Addendum No. 001

Subject: Mechanical Plant Replacement Bid Package
Mechanical
SDP Contract No. B-045 (c) of 2017/18

Location: Arts Academy at Benjamin Rush
11081 Knights Road
Philadelphia, Pennsylvania 19154

DRAWING NO.
M001

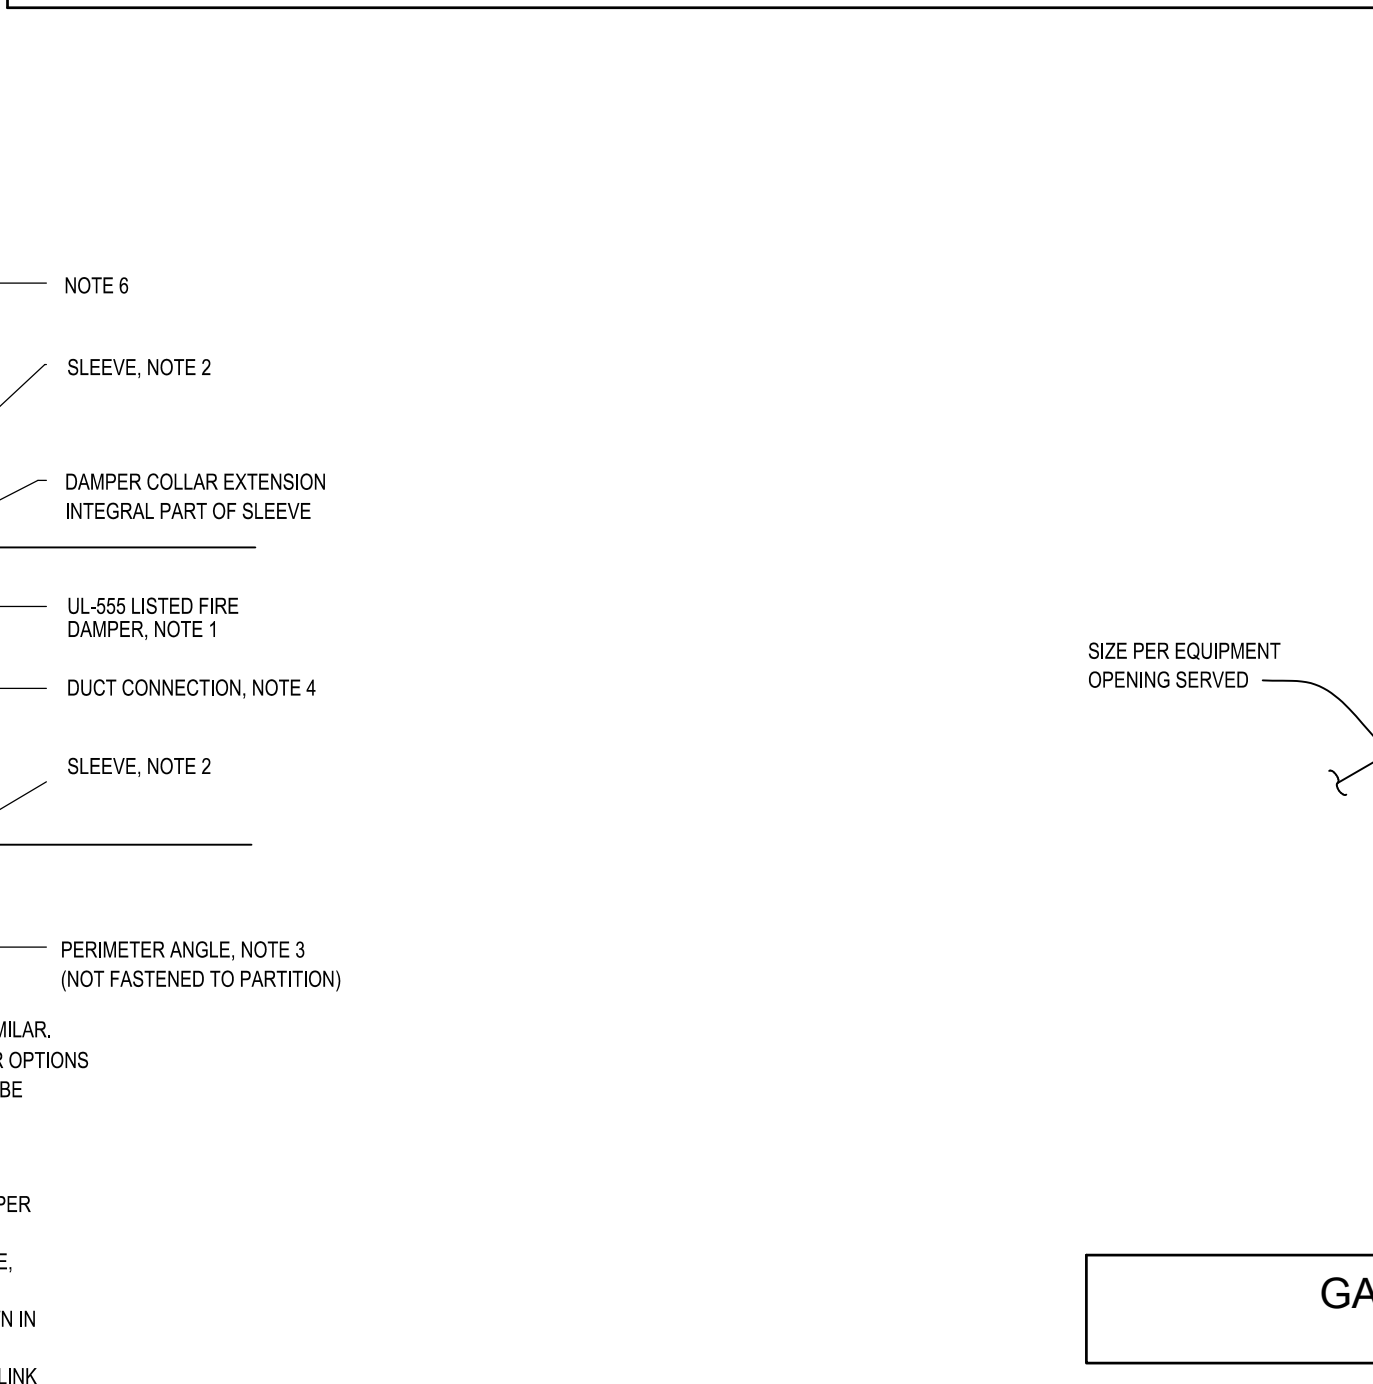
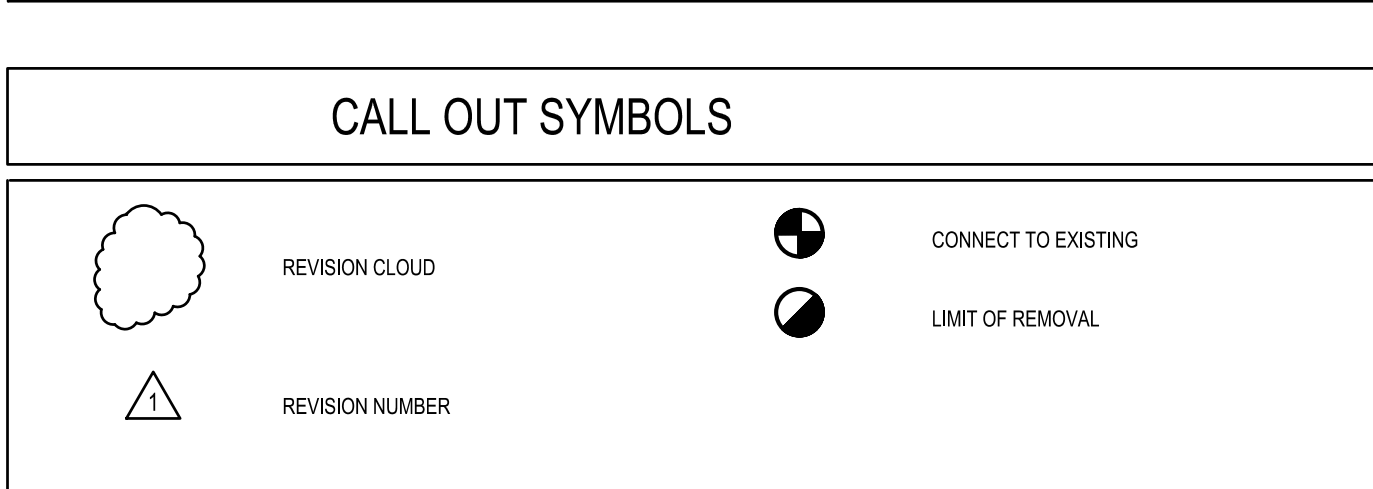
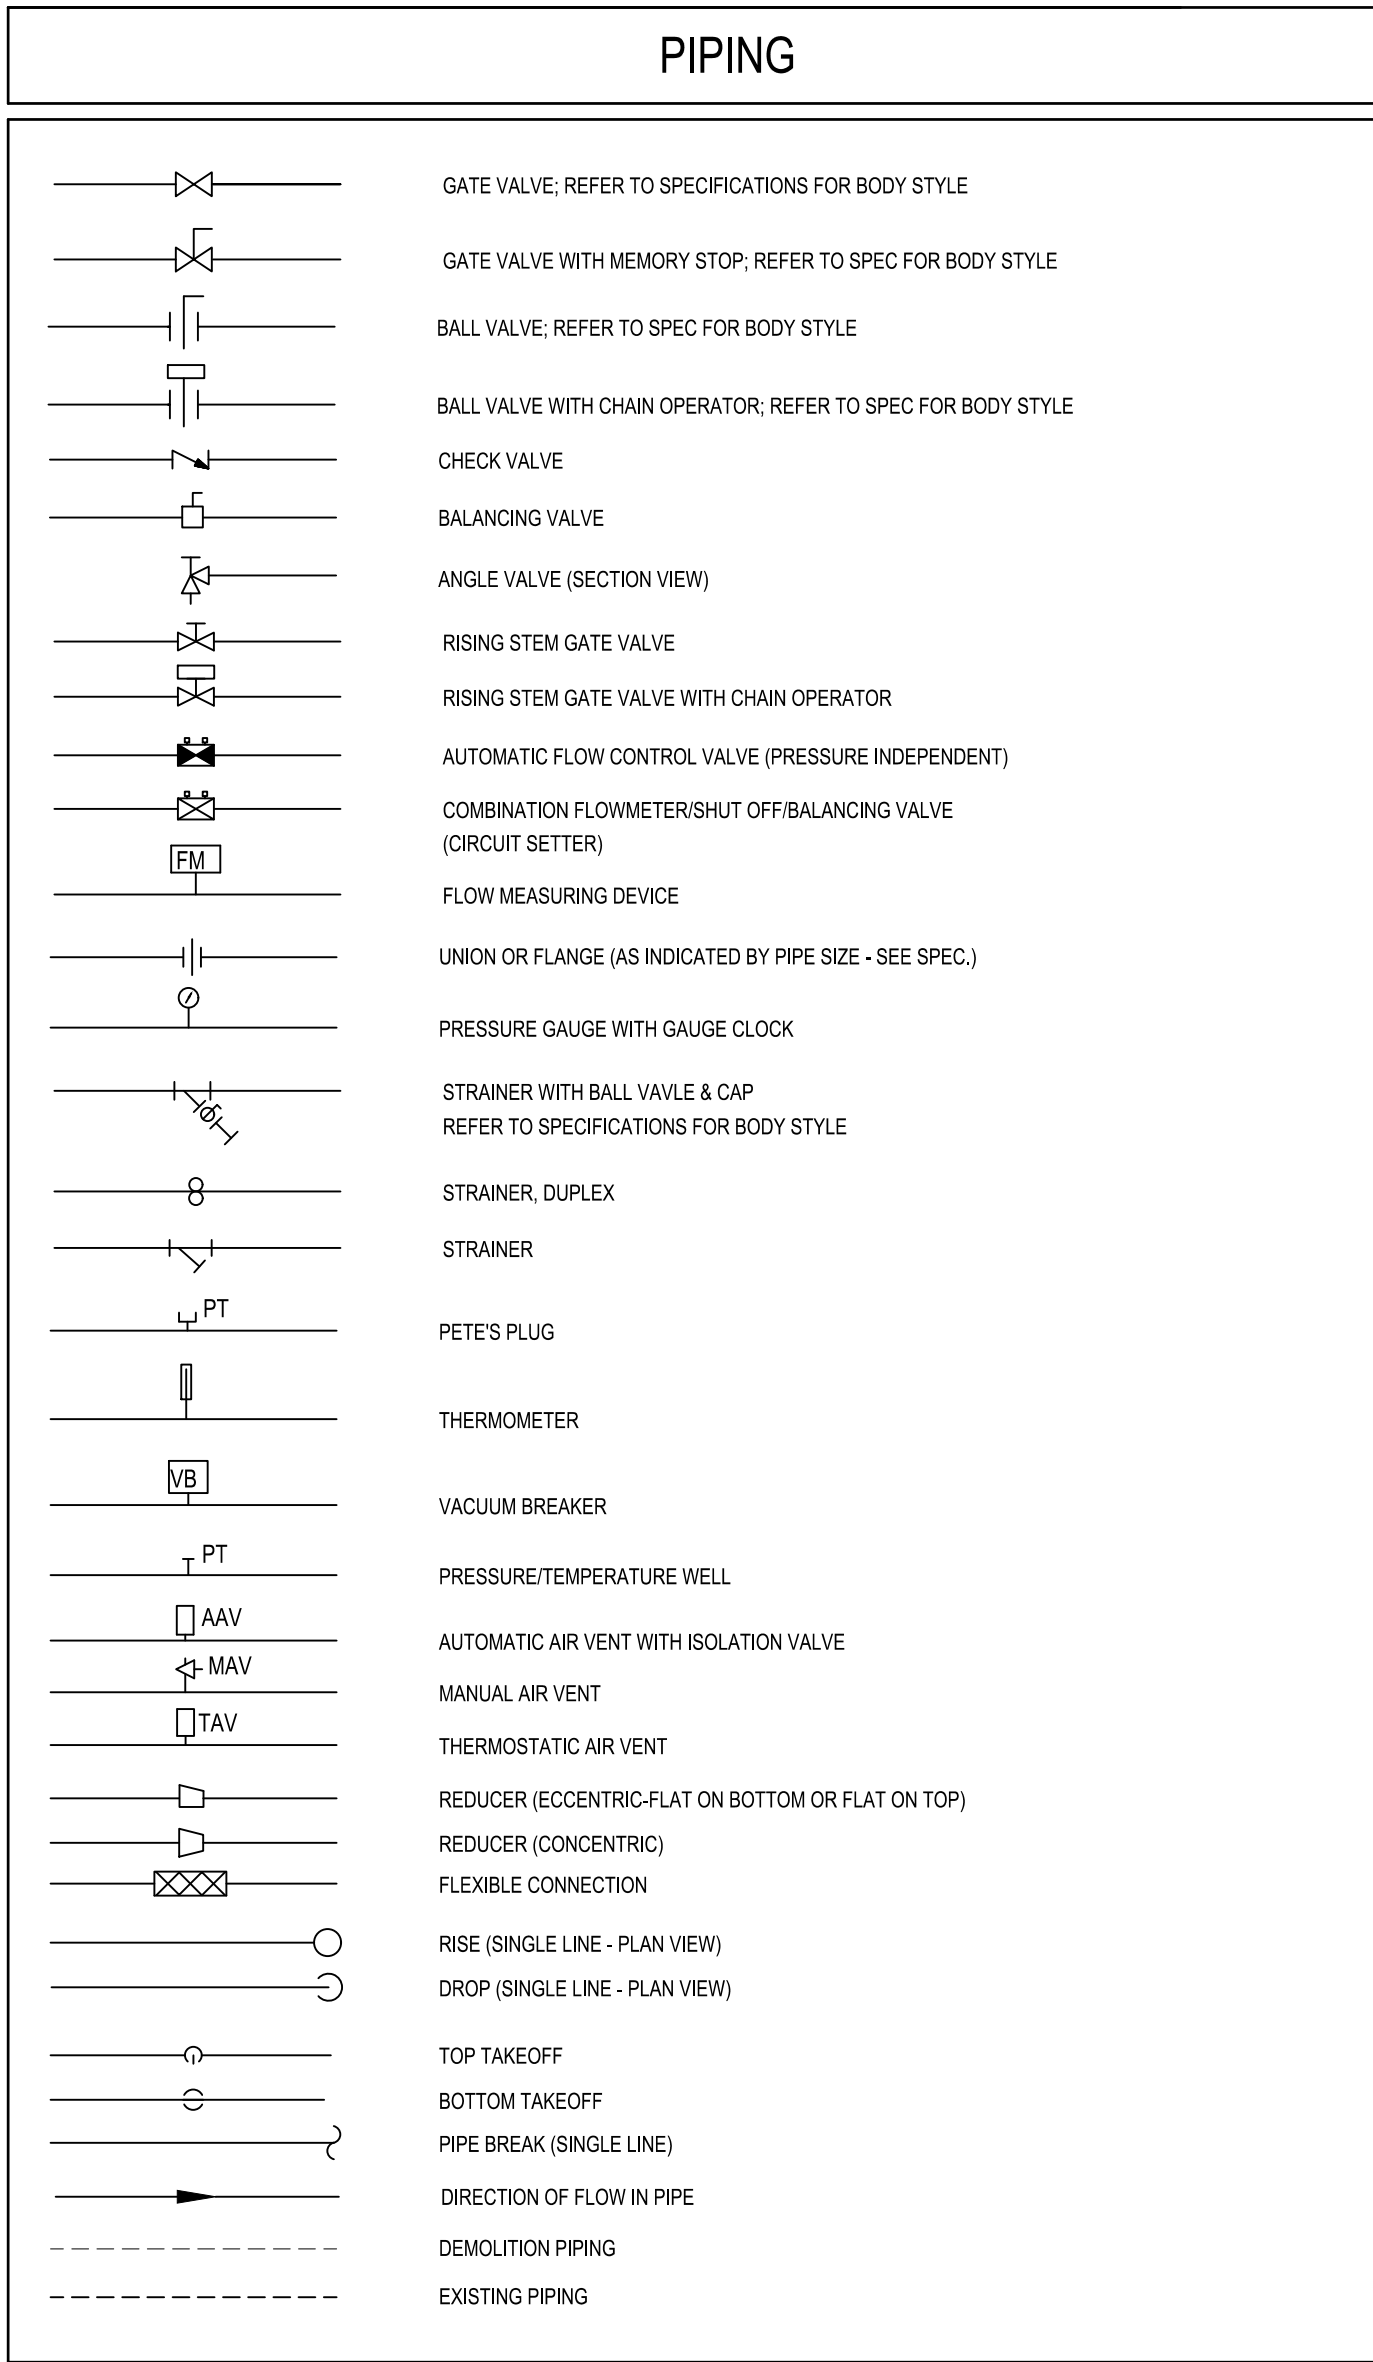
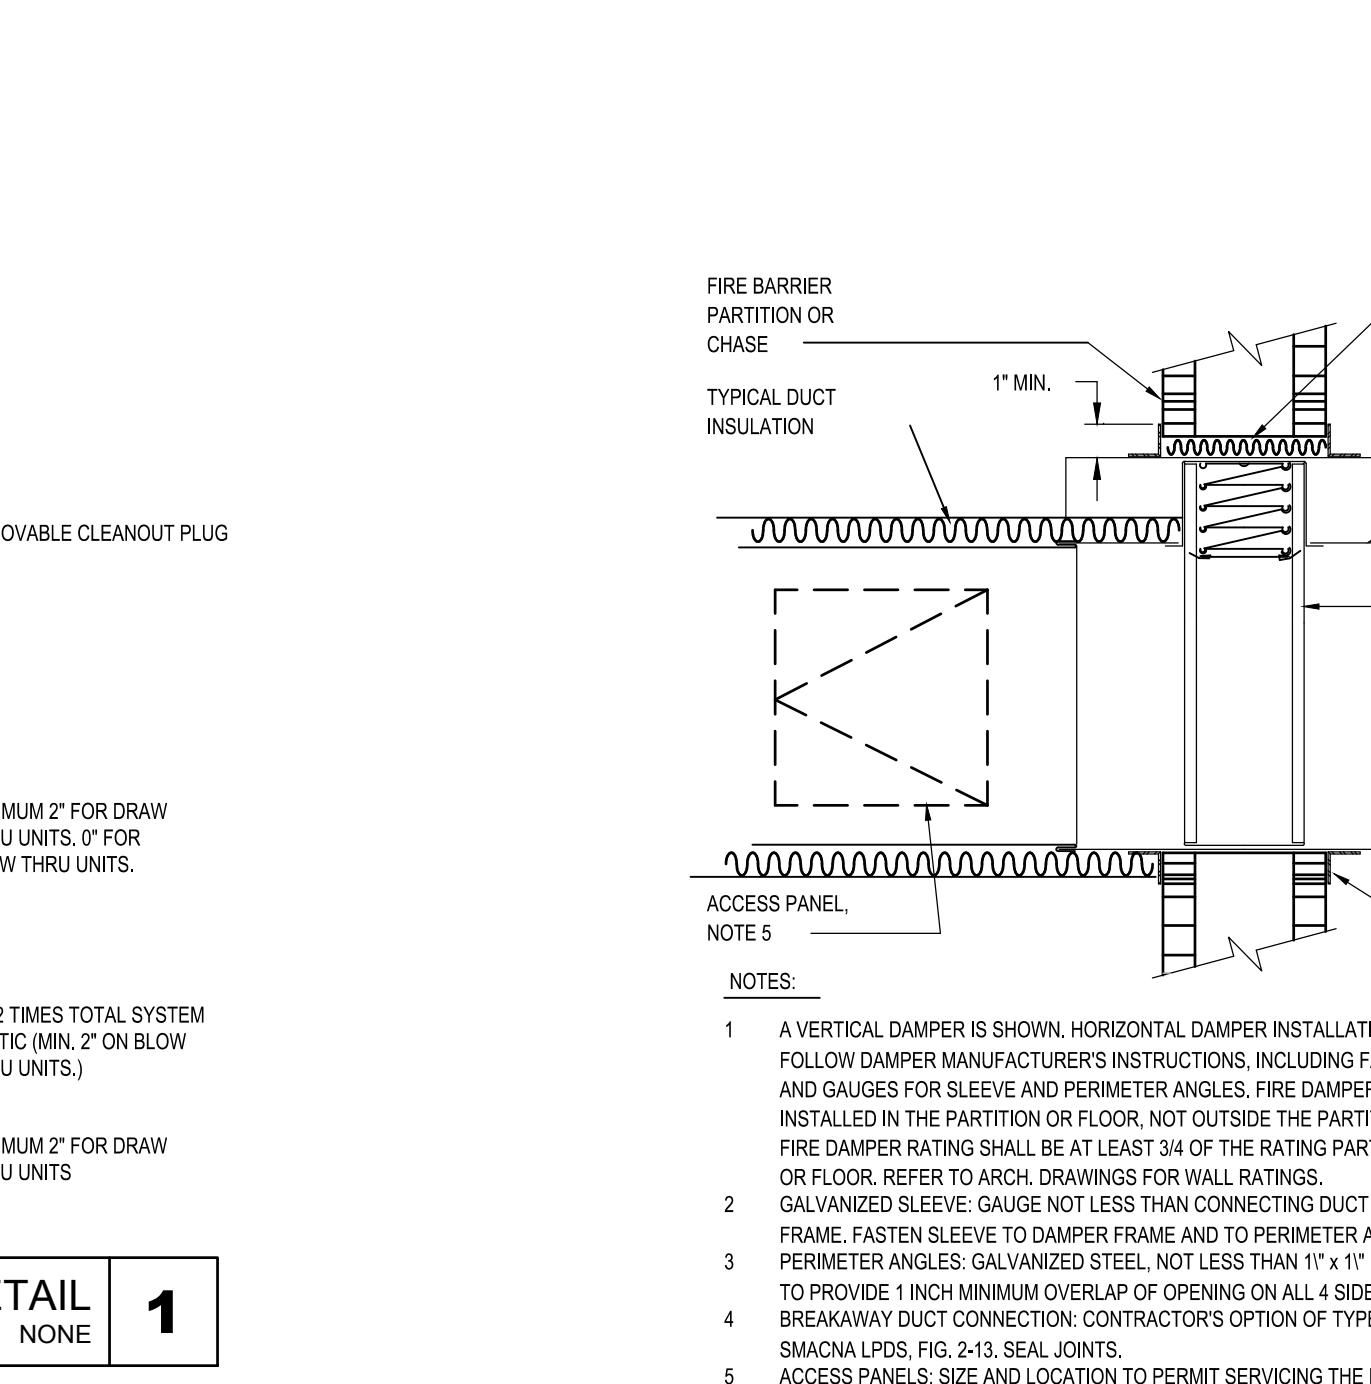
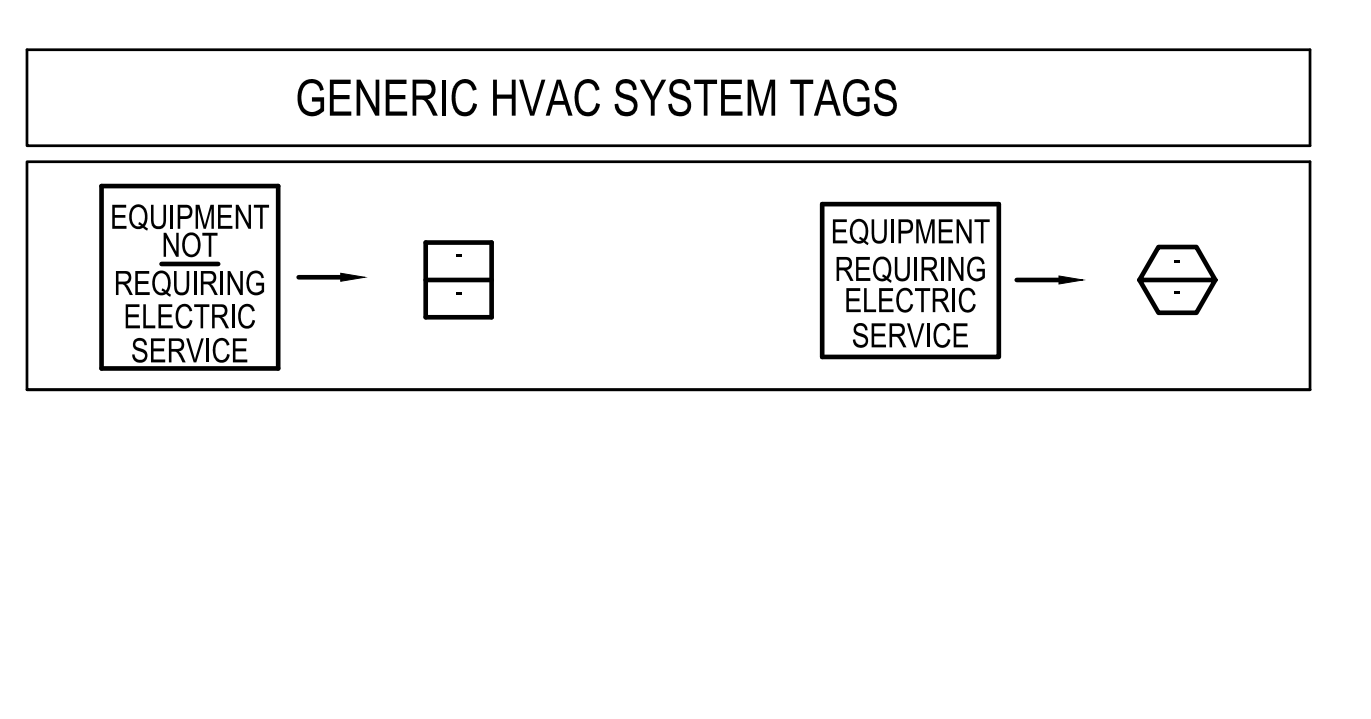
- 2.1.3** Drawing revision M001 – Revised Drawing Changed Drawing Number System legend.
- 2.1.4** Drawing revision MD100 – Revised Drawing Key Note 1 to include Mechanical Contractor shall paint the entire affected wall with 2 coats of paint.

DRAWING NUMBER SYSTEM
